Amendment Report

Crows Nest OSD (Site A) –Detailed SSDA
(as amended) | SSD-75660711

**Submitted to the Department of Planning, Housing and
Infrastructure
on behalf of Thirdi Crows Nest Commercial Developments Pty Ltd**

7 November 2025

Figure 2 Commercial grid adaptation to residential (Source: Woods Bagot, Appendix H)

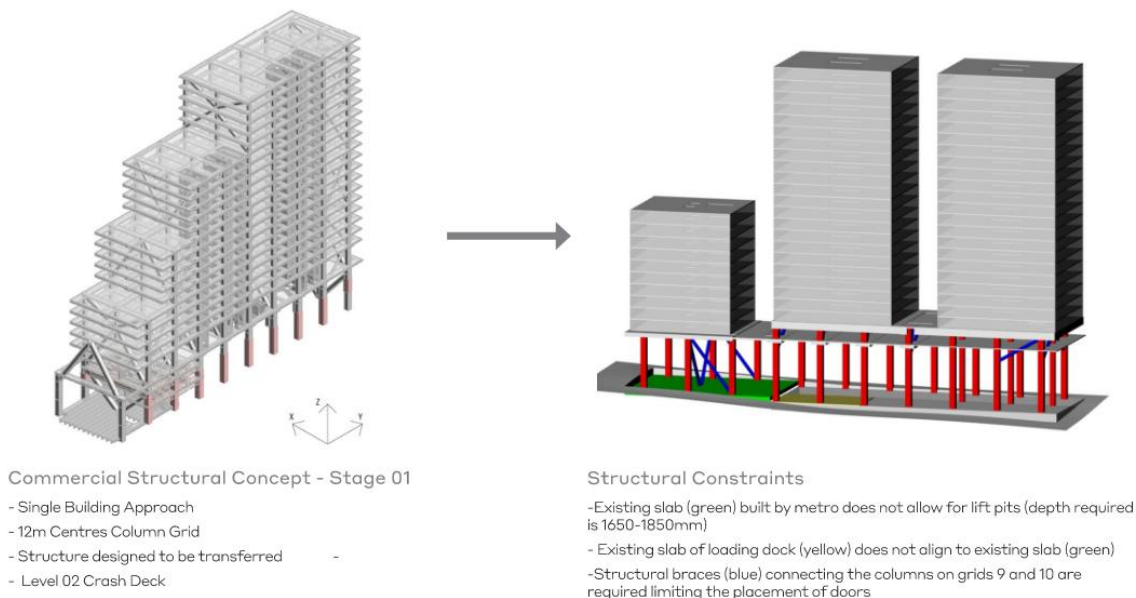
- The as-built Metro slab (shown in green in at Figure 2 below) does not allow for lift pits at the required depths of 1650-1850mm.
- The as-built loading dock slab (shown in yellow at Figure 2 below) does not align with the metro slab (shown in green)
- Diagonal structural braces (shown in blue at Figure 2 be) are required from ground to level 4, but limit the location of the doors
- Given the ground floor access restrictions for Tower 1 and 2, no underground services can be provided and are required above ground which impacts the usable retail space

Figure 4 Long Section Exert showing height of buildings (Source: Woods Bagot)

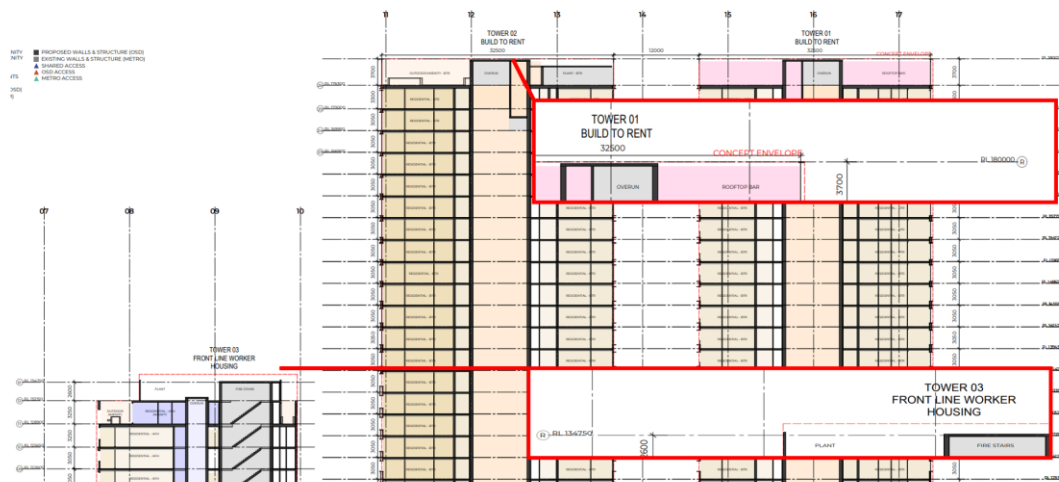
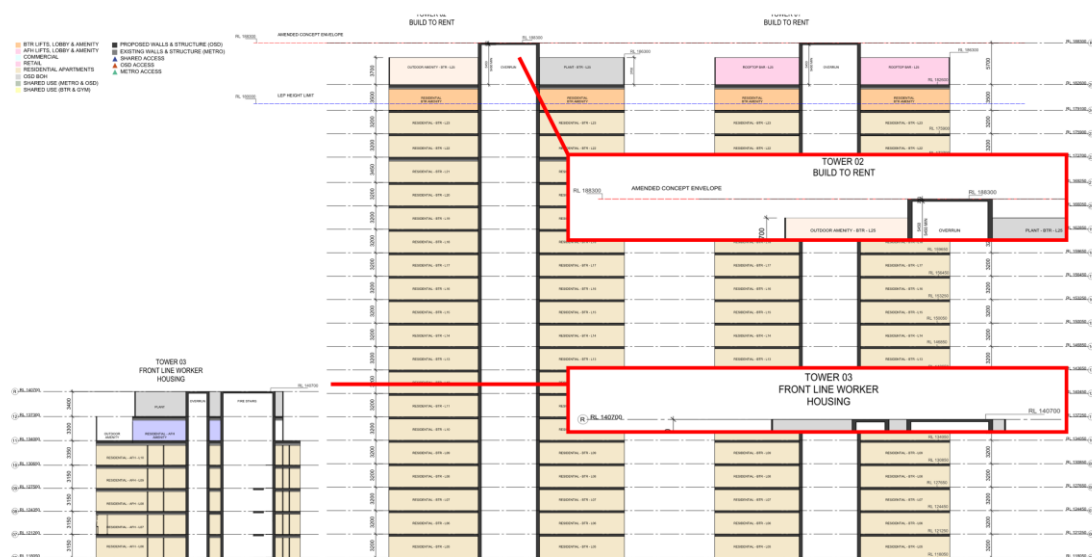
- Rooftop level – increase in the height of the lift overrun by 2m as a result of technical lift feedback to service the rooftop (3.7m to 5.7m)

This increase is to accommodate building services to be located at each residential level to facilitate the delivery of the OSD. This change alone adds 5.2m to the change in height.

Figure 5 Current proposed long section highlighting removal of Level 25 for Tower 1 (Source: Woods Bagot)

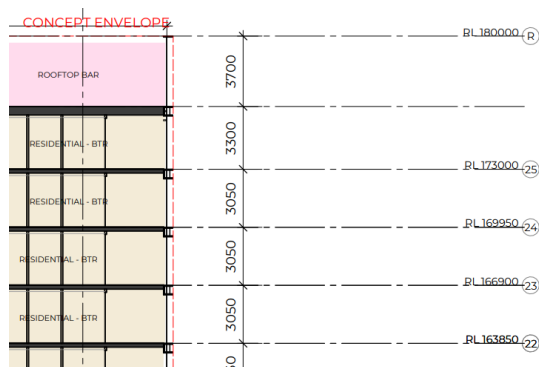
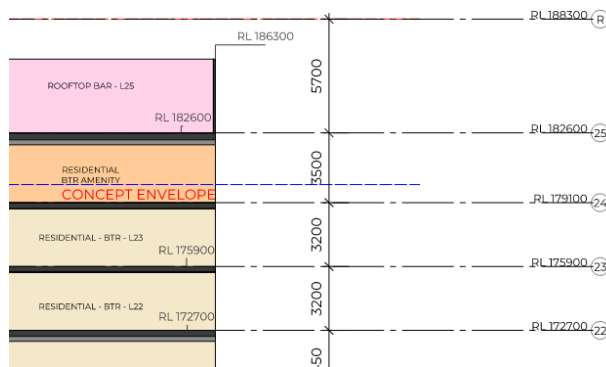
Level 25 has been removed to minimise the extent of the height exceedance and to respond to concerns during exhibition relating to amenity (refer to the Detailed RtS Report). Level 24 on both Towers 1 and 2 has been converted from residential to communal indoor space to improve amenity across the proposal and is detailed at section 4.8 of this report and illustrated in the following figures.

Figure 5 Proposed perforated metal screening for apartments facing the opposite tower, shown in red (Source: Woods Bagot)

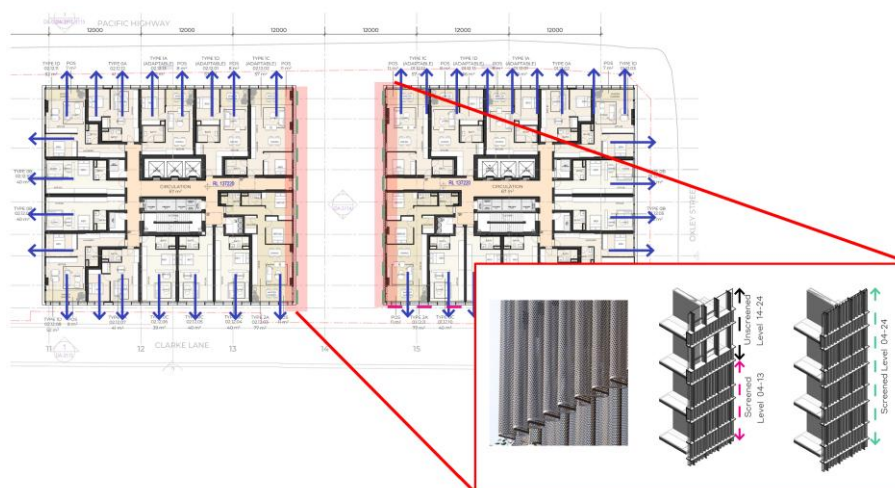
Given the building separation as the site is constrained by the metro-box, additional visual privacy treatment have been included to improve amenity outcomes. Screening on the eastern façade of Tower 1 and 2 has been included from Level 4 to Level 13 to improve privacy to a future permissible development at the adjoining site 28- 34 Clarke Street. Perforated metal screening is also proposed between Tower 1 and 2 to help control outlooking and provide privacy from other units given the 12m separation all the way up the building (Figure 5 overleaf).

Figure 9 Lower Ground Level, northern portion, proposed (Source: Woods Bagot)

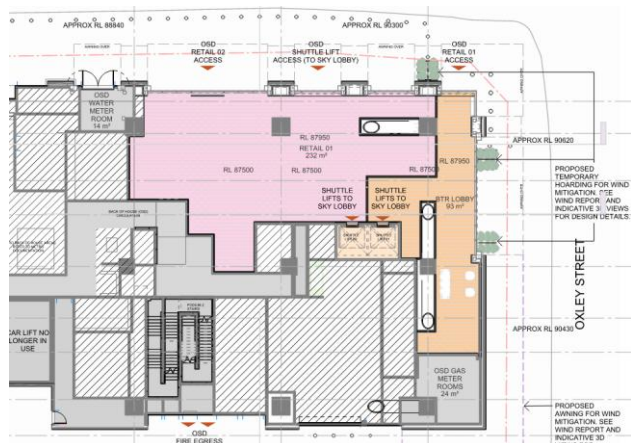
The lower ground level has been reconfigured to provide an improved internal layout and design that allows for retail spill-out and greater opportunities for activation through a continuous street frontage, encouraging social interaction and enhancing the overall precinct feel. Previously Retail 01 and 02 (Figure 8) have been consolidated into Retail 01 (Figure 9) to improve the functionality and flexibility of the tenancy layout, supporting a more practical use of the area. This reconfiguration also improves the access for residents, providing a clear and identifiable entry point that is separate to the retail use.

Figure 11 Amended Level 3 Bar Lobby Space (Source: Woods Bagot)

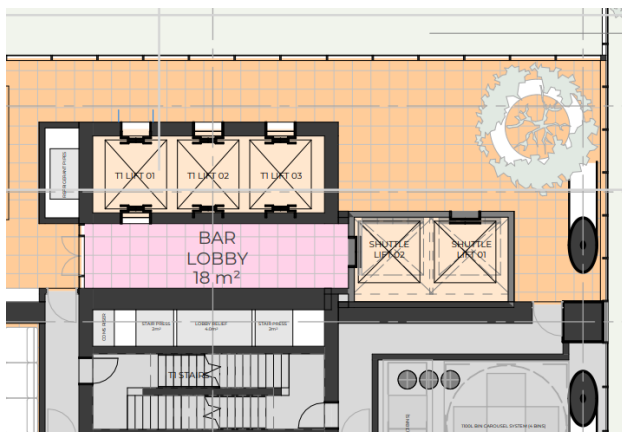
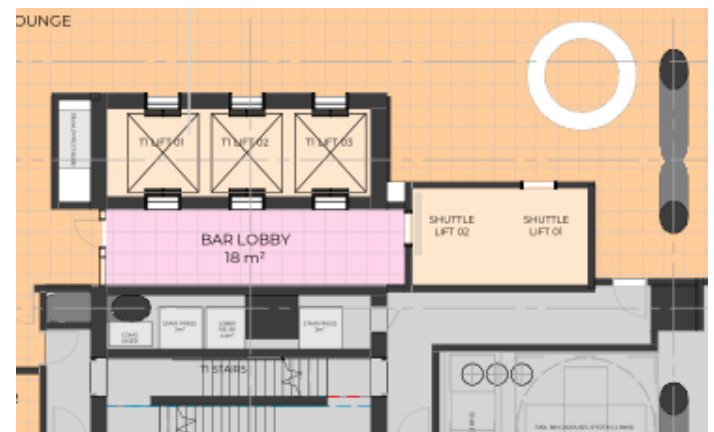
Retail 01 (formerly Retail 01 and 02) will be retained as a bar and connected to the rooftop bar located on Tower 1. The vertical articulation has been improved to enable direct travel from Level 3 to the rooftop.

For patrons of the rooftop bar, they will access Shuttle Lift 02, located at the rear of Retail 01 which will transport them to the Level 3 lift transfer space before connecting to the tower lifts servicing the rooftop. Shuttle Lift 02 opens to the Bar Lobby at Level 3 which will have security to direct bar patrons to Lift 1 which has direct access to the Rooftop.

This amendment restricts access for Lift 1- 3 to open only to the Bar Lobby at Level 3. Residents accessing the Sky Lobby or residential levels will require access cards to prevent bar patrons entering the residential areas (Figure 12). Furthermore, using an advanced control system (DCS) will enable Lift 1 to be allocated to the rooftop bar only when required from Level 3. The purpose of this is to maintain separation between bar patrons and residential users, ensuring that the rooftop bar lobby operates independently from the residential entry and circulation areas. This separation provides a clear distinction between public and private uses, enhancing security, privacy, and amenity for future residents.

Figure 12 Rooftop Bar Access Route (Source: Woods Bagot)

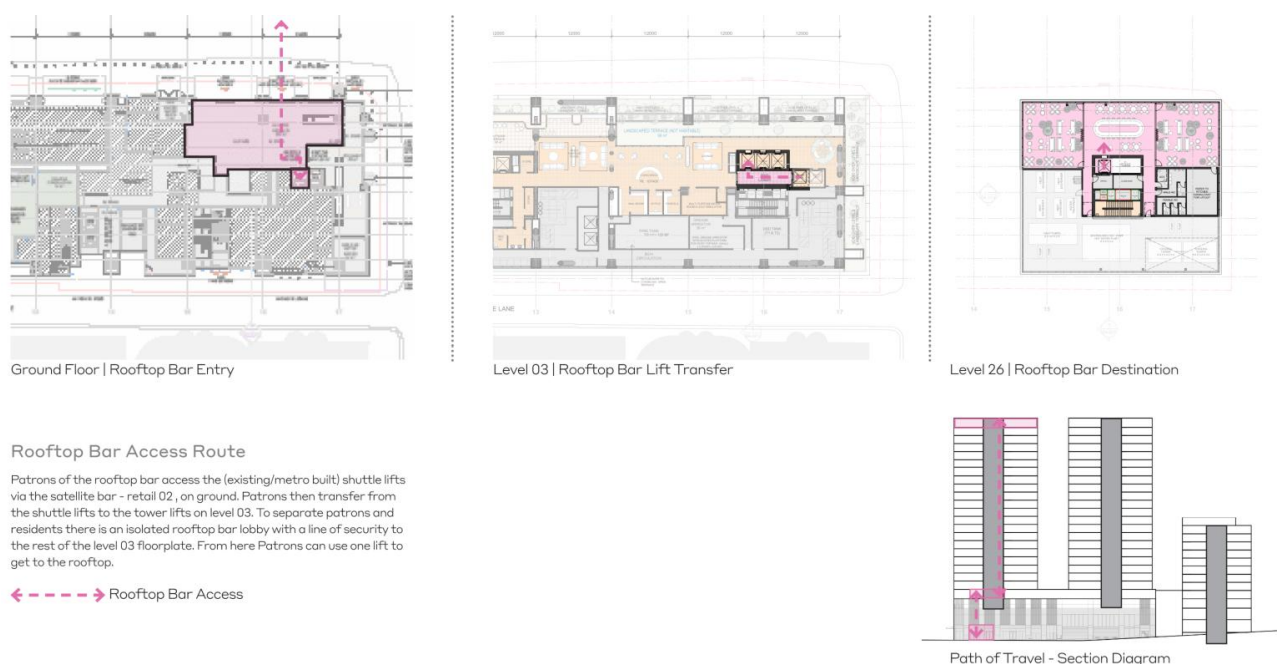
The Design Report (Appendix H) has been amended to include details of the access route to the rooftop bar, as shown in Figure 12 below.

Figure 13 Originally submitted Level 3 Plan (Source: Woods Bagot)

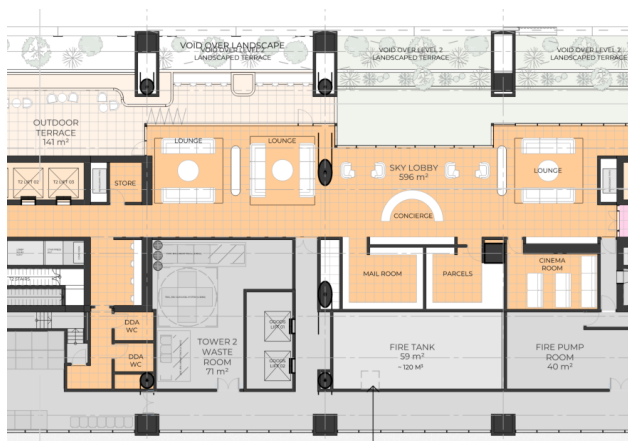
- Level 3 Sky Lobby (Figure 13 and Figure 14)
 - The parcel room has been reduced to accommodate the inclusion of an Office
 - The Cinema room has been converted into a Multipurpose Room
 - The bathroom and fire egress stairs have been reconfigured to improve functionality
 - Increase of storage spaces
 - Increase in internal area to improve circulation
- Level 3 AFH Tower 3 (Figure 15 and Figure 16)
 - The provision of space for services near the lobby (i.e. mechanical risers and exhaust system) as a result of final design development and re-cutting the mix of units and their entry points
- Level 4 - 23 BTR Tower 1 and 2 (Figure 17 and Figure 18)

Figure 18 Layout for Level 4-24 of BTR Towers (Source: Woods Bagot)

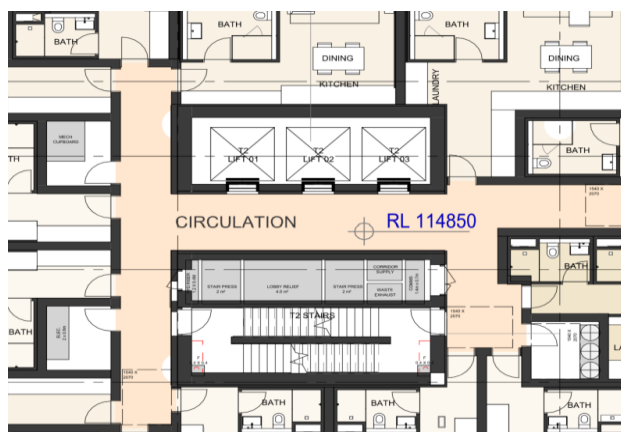
- Reconfiguration of the services provided at each floors lobby including waste chute rooms, electrical and mechanical rooms as a result of final design development and re-cutting the mix of units and their entry points

Figure 22 Amended Level 3 outdoor terraces (Source: Woods Bagot)

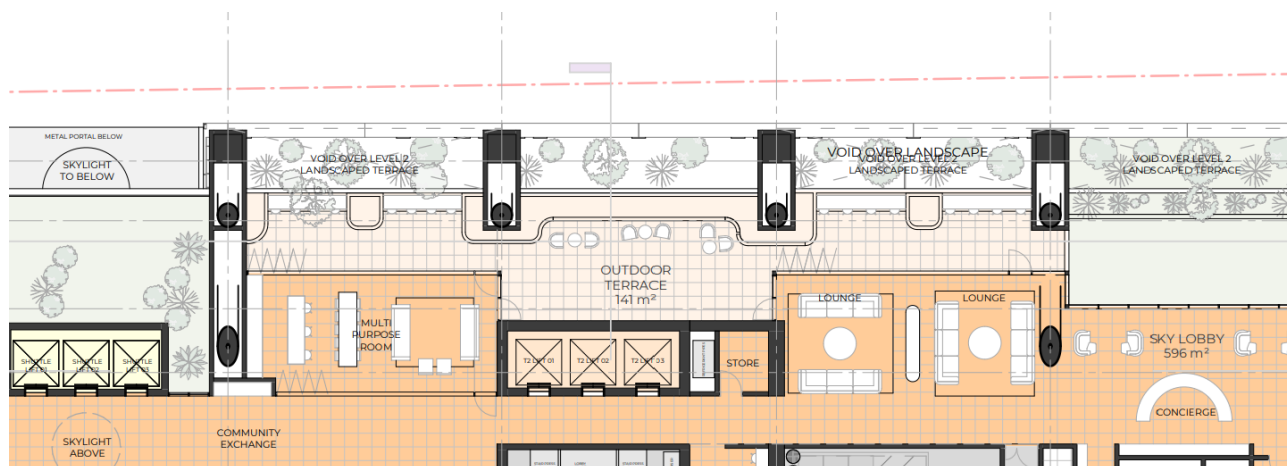
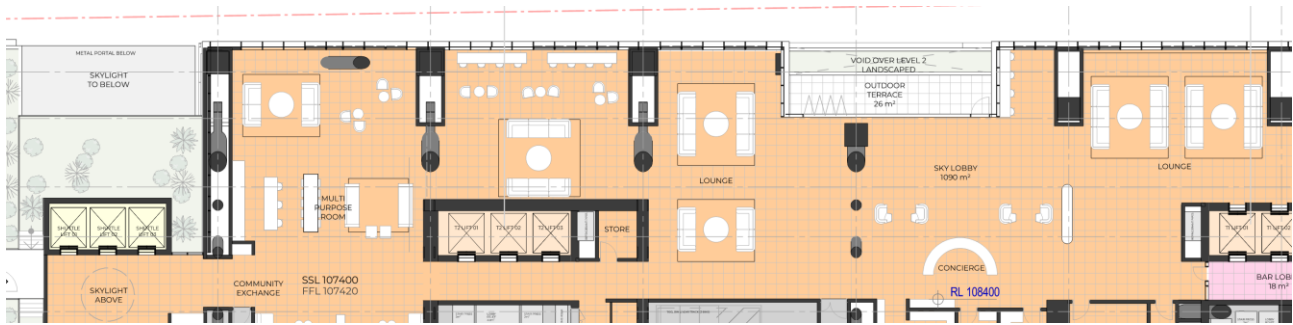
As a result of the façade treatment changes detailed at section 4.10 below, the terraces located on Level 3 and Level 4 have been, respectively, converted into the sky lobby and reduced in size. The Level 3 outdoor terraces located on the Pacific Highway frontage has been converted to GFA forming part of the sky lobby. This change has been made to design a more coherent façade treatment, fronting Pacific Highway. The Level 4 outdoor terrace has been recessed in to create a greater visual separation between Towers 1 and 2 and maintain proportions of the originally submitted scheme. While there has been a reduction in the provision of outdoor COS as a result of this change, the quantum of COS on merit (internal and external) is still greater than that originally proposed and delivers a greater diversity of spaces. This is shown in the figures below.

Figure 25 Ground Floor Plan, annotated showing proposed awning (Source: Woods Bagot)

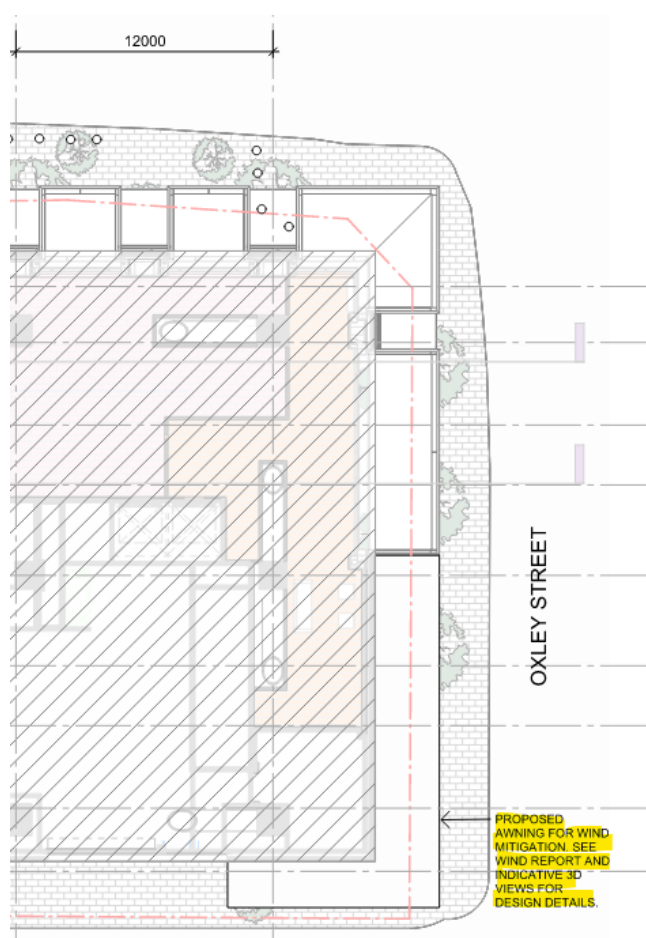
In response to the DPHI's request to identify and implement the recommendations in the Pedestrian Wind Assessment (Appendix V), the architectural and landscape design teams have updated the relevant reports and plans to include the following:

- Ground Level (Figure 25 below):
 - Continuation of the awning along Oxley Street, wrapping around to Clarke Lane to mitigate the north-easterly winds impacting the local exceedance at the corner of Oxley Street and Clarke Lane.
 - Inclusion of 3 temporary planter boxes and hoarding along Oxley Street to mitigation wind.
- Level 4 Terrace (Figure 26 below)
 - 2 x 1.8m high glass screens along the eastern and western perimeters to mitigate wind.
 - In addition to the glass screen, changes to the planting schedule along the eastern and western perimeters to improve wind mitigation through natural screening. The lilly pilly's proposed to be planted are capable of growing to 5, to provide additional shelter to the winds.

Figure 27 Render Comparison of Façade changes shown in red (Source: Woods Bagot)

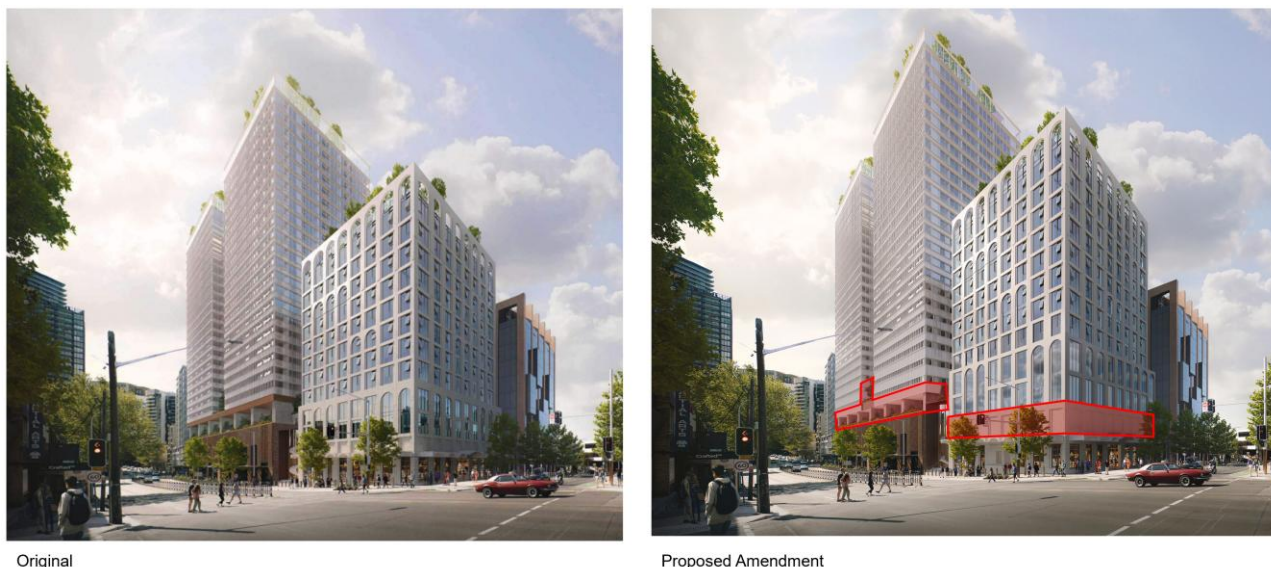
This has resulted in a change to the overall visual balance and proportions of the lower levels shown at Figure 27 below.

As detailed in the Design Report (Appendix H) and Photomontages (Appendix J), Woods Bagot have undertaken a detailed review of the façade treatment to ensure a robust and cohesive design is proposed. The review has focused on ensuring an appropriate sense of scale, articulation and visual hierarchy is maintained and consistent with the projects overall design intent and surrounding context.

Figure 32 Exert of proposed amendment to Level 3 Plan (Source: Woods Bagot)

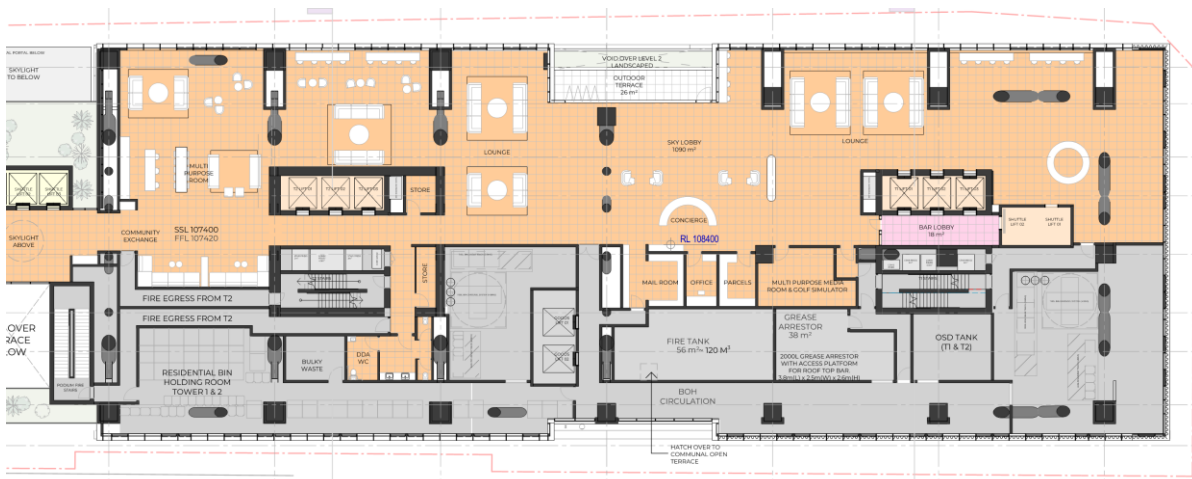
The design of the communal open space on Level 3 and 4 has resulted in a 93sqm reduction in the overall COS but this has on balance increased due to the conversion of Level 24 to internal COS. The Level 4 COS has been positioned to maximise solar access throughout the year and the additional planting along both edges has been proposed to improve usability through reduce wind impacts. This also helps to enhance the environmental quality of the COS. The slight reduction is due to recessing and creating separation between Towers 1 and 2 to create a balanced façade.
